DEVELOPMENT APPLICATION ASSESSMENT REPORT

Application Number:	DA2020/1289
----------------------------	-------------

Responsible Officer:	Anne-Marie Young
Land to be developed (Address):	Lot 9 DP 15762, 11 Bruce Street MONA VALE NSW 2103
Proposed Development:	Demolition works and construction of a dwelling including swimming pool
Zoning:	E4 Environmental Living
Development Permissible:	Yes
Existing Use Rights:	No
Consent Authority:	Northern Beaches Council
Land and Environment Court Action:	No
Owner:	Barry Norman Edward Hastie Cynthia Marion Handley
Applicant:	James de Soyres & Associates Pty Ltd

Section showing elevated driveway over Council's road reserve.

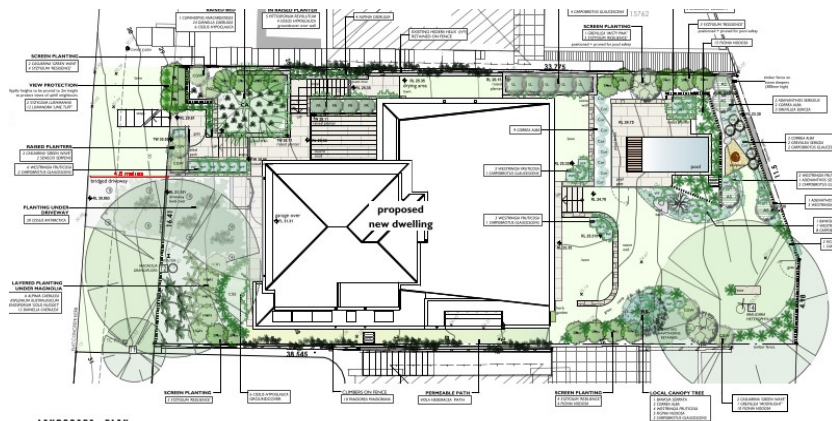
The proposed driveway has been modified to generally address the engineering concerns subject to conditions requiring further design amendments to remove the elevated slab to the edge of the carriageway. The elevated section of the driveway over the grassed road reserve equates to a length of 2.3m and a height of 1.5m.

Subject to a reduction of the extent of the elevated driveway on the road reserve the proposed driveway has been assessed as acceptable in terms of the streetscape particularly given that the existing mature magnolia tree will be retained and supplemented with additional planting to integrate the development and reduce the dominance of the structure. Further, given the context of the site, refer to photos below, the proposal will meet the objectives of Clause D14.1 and generally achieves the character of the
